**Re.** : Amendment and Response to Office Action Mailed September 16, 2005  
**Appl. No.** : 10/668,746  
**Filed** : September 23, 2003

### **III. AMENDMENTS TO THE DRAWINGS**

#### **IV. REMARKS**

Fig. 2

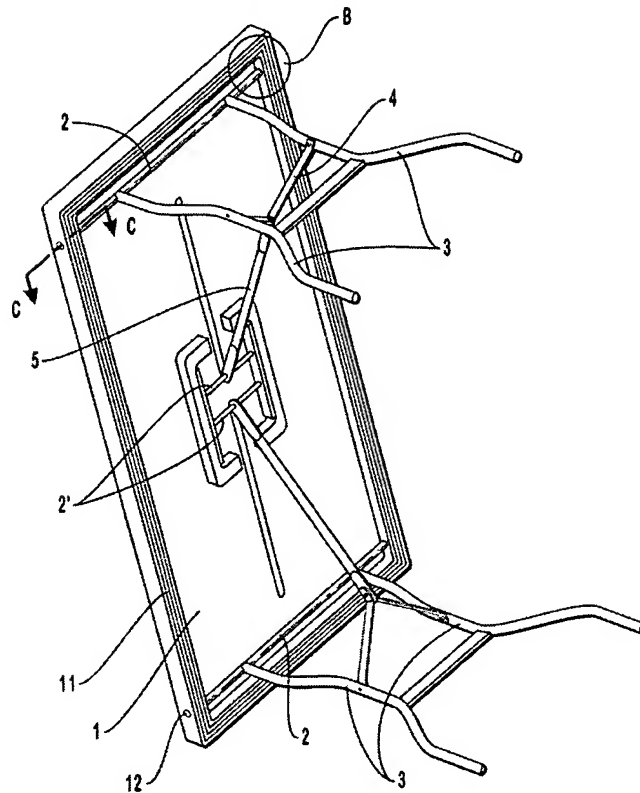
The Office Action objected to the drawings and stated that Figure 1 should be designated by a legend such as --Prior Art-- because only that which is old is illustrated. *See* MPEP § 608.02(g). The Office Action also objected to the drawings for failing to comply with 37 CFR 1.84(p)(5) because they do not include the following reference sign(s) mentioned in the description: 22. In addition, the Office Action objected to the drawings for failing to comply to 37 CFR 1.84(p)(5) because they include the following reference character(s) not mentioned in the description: B-3, B-4, and 2’.

As set forth above, Applicants amended the specification to conform the specification to Figure 2. In particular, Figure 2 illustrates that a center bar 2’ may be connected to a bar 5 and that the bar 5 may be connected to a strut 4:

Accordingly, Applicants amended paragraph [052] of the specification by replacing the reference 22 with the reference 2' to conform the specification to Figure 2:

Because the description no longer includes the reference 22, the drawings need not include the reference 22, and Applicants therefore request that the objection based upon the omission of the reference 22 from the drawings be withdrawn.

Further, because the description now includes the reference 2', the reference 2' need not be removed from the drawings, and Applicants therefore request that the objection based upon the inclusion of the reference 2' in the drawings be withdrawn.

Fig. 2

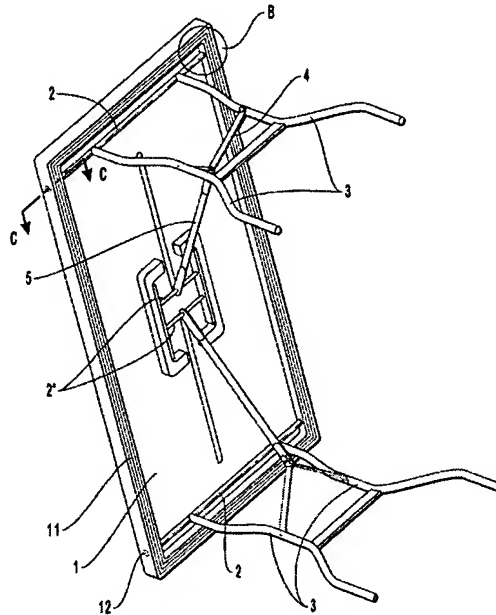
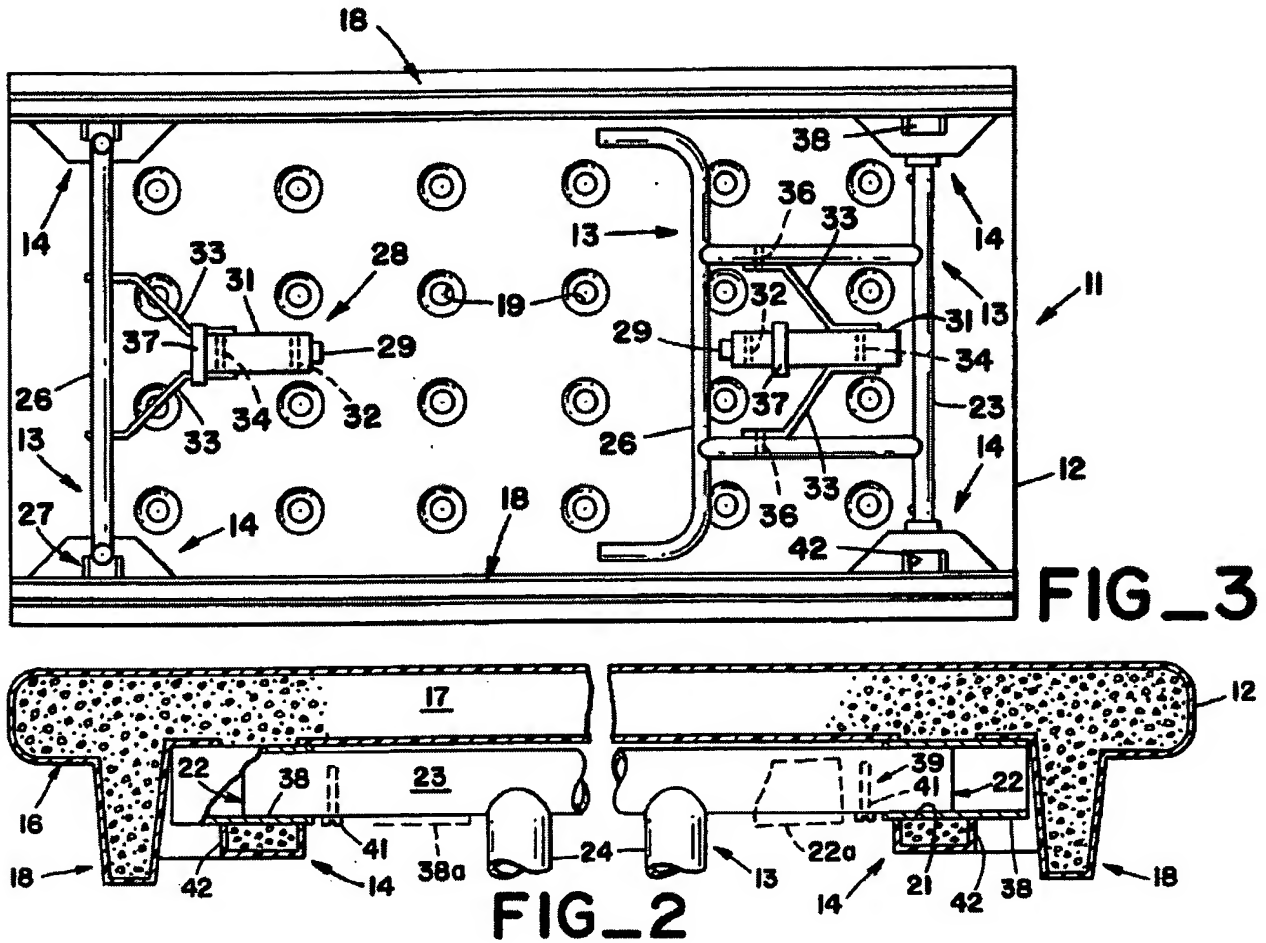
The Office Action rejected Claims 1, 4, 9, 13, and 18 under 35 U.S.C. § 102(b) as being anticipated by U.S. Patent No. 5,394,808 issued to Dutro. In particular, the Office Action stated that the Dutro patent teaches a table (Fig. 1) comprising: a plastic molded table top (12) having a lip (14) with interior, outer and bottom surfaces, a first connecting aperture (inner opening) located in the interior surface and a second connecting aperture (outer opening) located in the exterior surface; a sleeve (38); a first table leg (24); and a first cross pole (23) attached to a first end of the table leg and disposed in the first and second connecting apertures. The Office Action stated that, since the Dutro patent teaches all of the structural limitations found in the method claims; the method steps would inherently be provided for.

Also, Figure 2 illustrates that a table may include the lips, the bar '2 and a brace assembly that may include a support bar 5 and a strut 4:

Applicants respectfully traverse this rejection because the Dutro patent fails to disclose each and every limitation of Claims 1, 4, 9, 13, and 18. Nevertheless, as mentioned above, to further clarify, more clearly define and/or broaden the claimed invention, and expedite receiving a notice of allowance, Applicants have amended Claim 1 to recite “a blow-molded table top including a top surface and a bottom surface,” “a lip extending outwardly from the bottom surface, the lip including an interior surface, and outer surface, and a bottom surface,” “a first connecting aperture formed in the interior surface of the lip,” “a first sleeve having a first end and a second end, the second end of the first sleeve being at least partially disposed in the first connecting aperture,” “a first table leg,” “a bar including a first end and a second end, the first end of the bar at least partially disposed in the first sleeve,” and “a brace assembly connected to the first table leg and the bar.” **Thus, Claim 1 now recites a blow molded table top including a lip, a first connecting aperture formed in an interior surface of the lip, a first sleeve including an end at least partially disposed in the first connecting aperture, a bar including an end at least partially disposed in the first sleeve, and a brace assembly connected to the first table leg and the bar.**

Support for this amendment may be found, *inter alia*, in Figure 2 and in the specification. For example, the specification states:

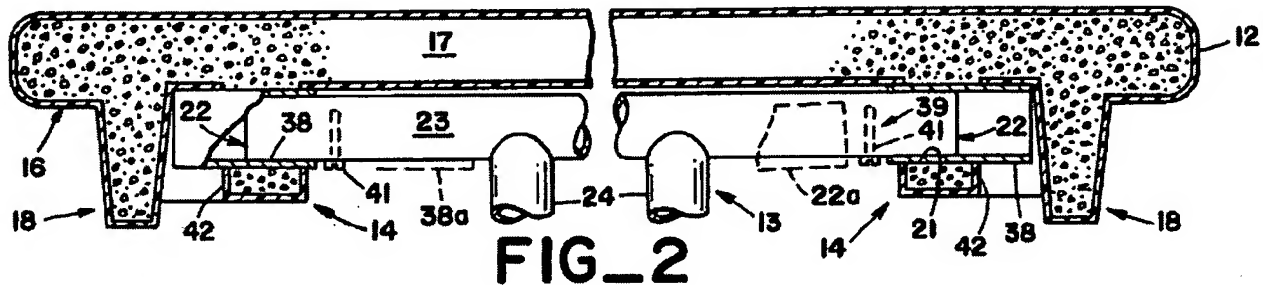
**In contrast, the Dutro patent discloses “means 28,” which is connected to the tubular members 24 and the bosses 29:**

**But the bosses 29 are not disposed within any sleeves.**

Fig. 1  
(Prior Art)

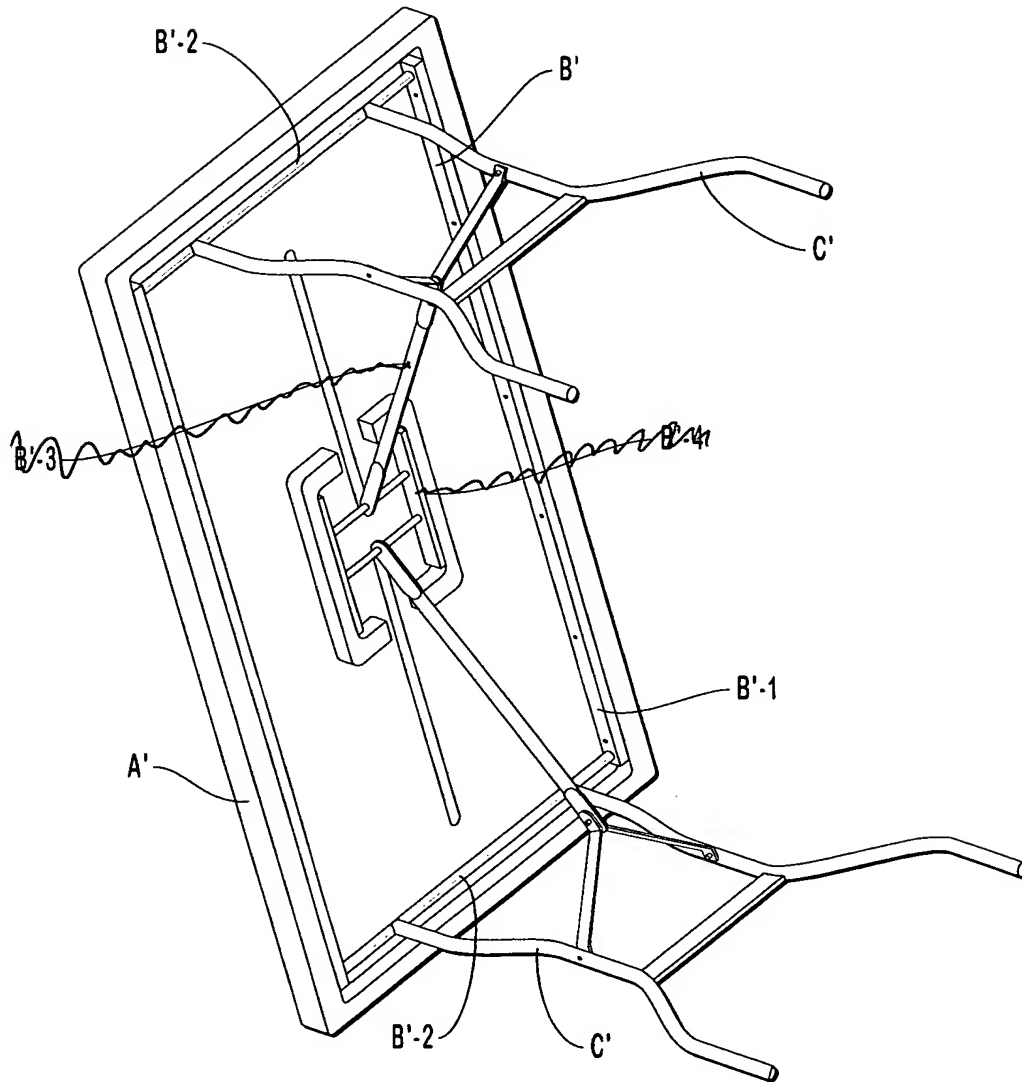
The attached replacement sheet of drawings includes an amendment to Figure 1 that adds the legend "PRIOR ART" to Figure 1 and removes references B'-3 and B'-4. This attached replacement sheet of drawings, which includes Figure 1, replaces the original sheet of drawings which included Figure 1.

An annotated or marked-up sheet of drawings for Figure 1 is also attached. The annotated sheet of drawings shows the proposed drawing corrections in red ink.

As set forth above, Applicants amended Figure 1 to include the “Prior Art” legend and therefore request that the objection based upon the omission of the “Prior Art” from the drawings be withdrawn.

Applicants amended Figure 1 to remove the references B’-3, B’-4 and therefore request that the objections based upon the inclusion of the references B’-3, B’-4 in the drawings be withdrawn.
